Service Category Drivetrain

Introduction

Some 2014 – 2017 model year Corolla and 2017 model year iM vehicles may exhibit a MIL "ON" condition with Diagnostic Trouble Code (DTC) P2820 present, indicating a Pressure Control Solenoid (shift solenoid valve SLP) Performance condition. The Engine Control Module (ECM) (SAE term: Powertrain Control Module/PCM) logic has been updated to prevent this condition. Follow the Repair Procedure below to address this condition.

Figure 1. Location of Authorized Modification Label for 2014 – 2016 Corolla and 2017 iM

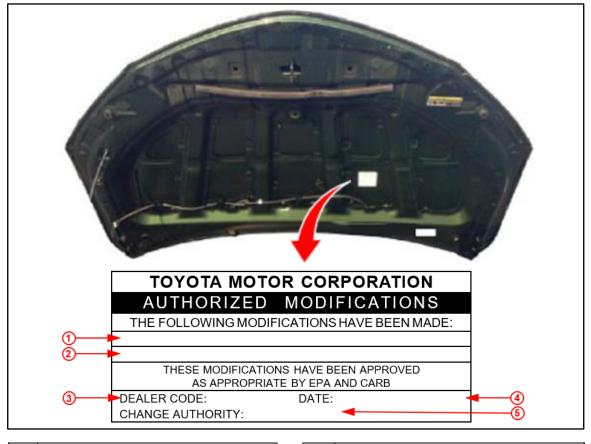
4. Check for the Authorized Modifications Label affixed to the vehicle in the location shown below. Confirm if the ECM (PCM) calibration has been updated.

Is the calibration ID listed the latest ECM (PCM) calibration?

- 6. Prepare and install the Authorized Modifications Label.
 - A. Using a permanent marker, enter the following information on the label:
 - ECM part number [Refer to the **Parts Information** section for the **NEW PART NUMBER**]
 - Calibration ID(s) [Refer to the **Calibration Information** section for the **NEW CALIBRATION ID**]
 - Dealer Code
 - Repair Date
 - Change Authority [This bulletin number]
 - B. Install the Authorized Modifications Label on the vehicle at the location shown in Figure 1. The Authorized Modifications Label is available through the MDC, P/N 00451-00001-LBL.
- 7. Perform the Techstream ECT Reset Memory Utility.
- 8. Test drive the vehicle to confirm the repair.
